The following information presented is the Uranerz Energy Corporation responses to the open issues for the Safety Evaluation Report for the Nichols Ranch ISR Project.

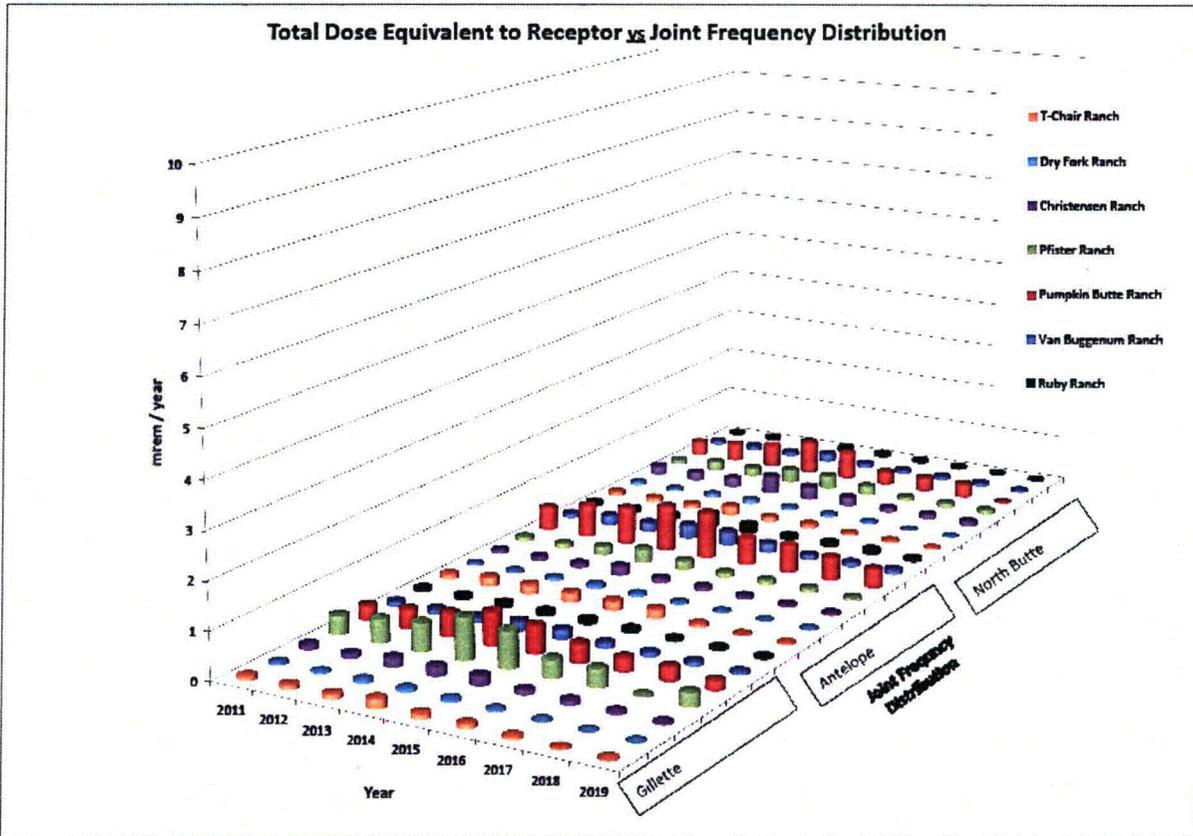
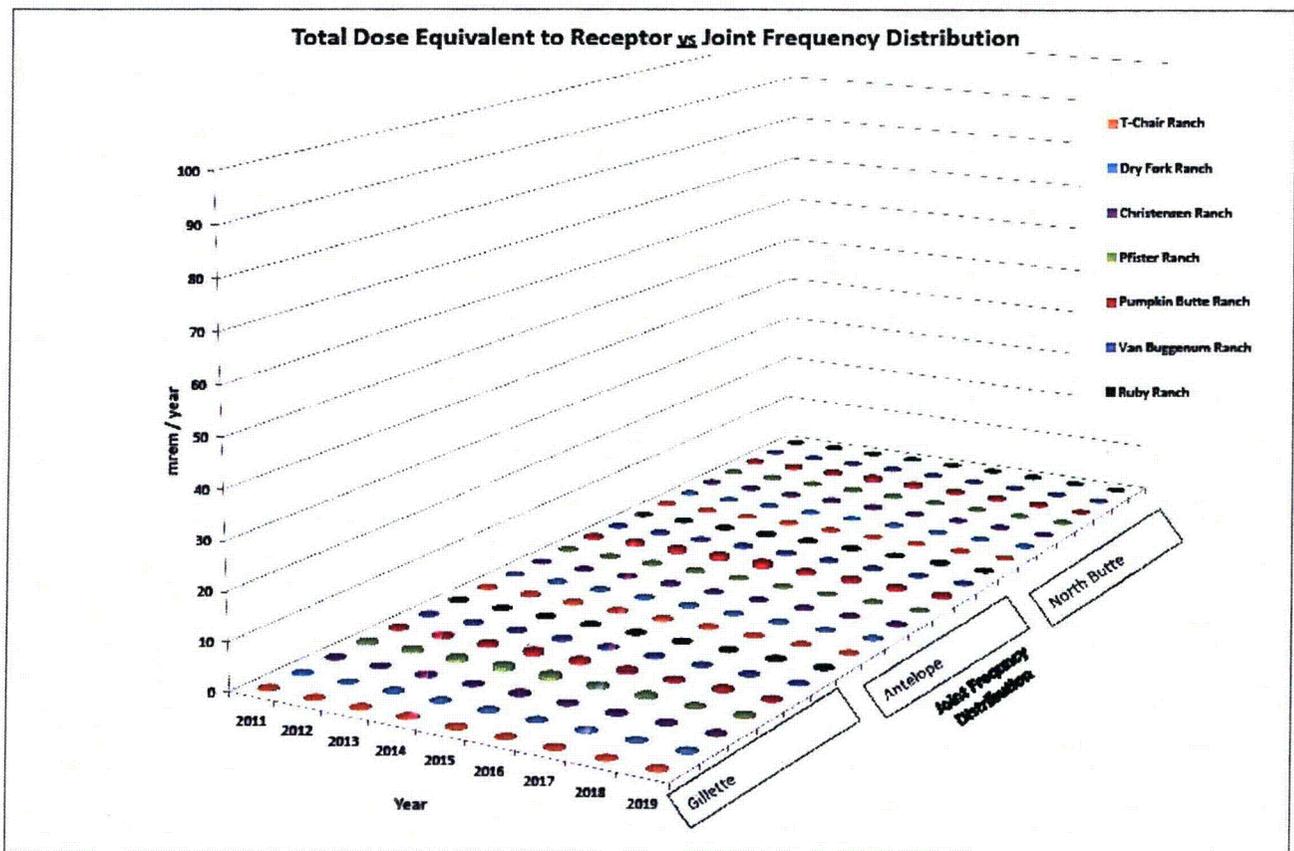
- 2.2.1 Uranerz has not provided sufficient information regarding the atmospheric stability of the site for the staff to evaluate its use of the Antelope station in lieu of site-specific data. A summary of the MILDOS methodology used to determine the atmospheric stability and the results contained in Addendum 7C should have been provided. **This is an open issue.**

Prior to this response, Uranerz had run the MILDOS model using two different atmospheric stability arrays: the first run utilized a long-term data set (1996-2005) from the National Weather Service (NWS) station at Gillette, which was obtained from the National Oceanic and Atmospheric Administration (NOAA); and the second data set was developed from a private meteorological station associated with the Antelope Coal Company. Additional details on the Antelope meteorological station (years of operation, data recovery, etc.) are provided in response item 2.5.1.

A review of the MILDOS results from the two previous submissions (see Chapter 7), shows that the use of the above-noted stability arrays did not cause a significant change in the predicted doses to the public. Because of the climatic similarities between Antelope and the Hank/Nichols Ranch project site, the similar results in the two MILDOS runs came as no surprise. Although this was the case, Uranerz decided to make a third MILDOS run to further demonstrate that the dose projections generated by the MILDOS model are not significantly different when using generally applicable stability data.

As can be seen from the new MILDOS results (attached to these responses) and the two graphs below, predicted dose values are in tight agreement with the previous estimates. All three runs demonstrate that any of the three sets of stability data are appropriate for use for the Nichols Ranch ISR project with all predicted does values being very small and very much under regulatory dose values. Therefore the Antelope data is appropriate for use.
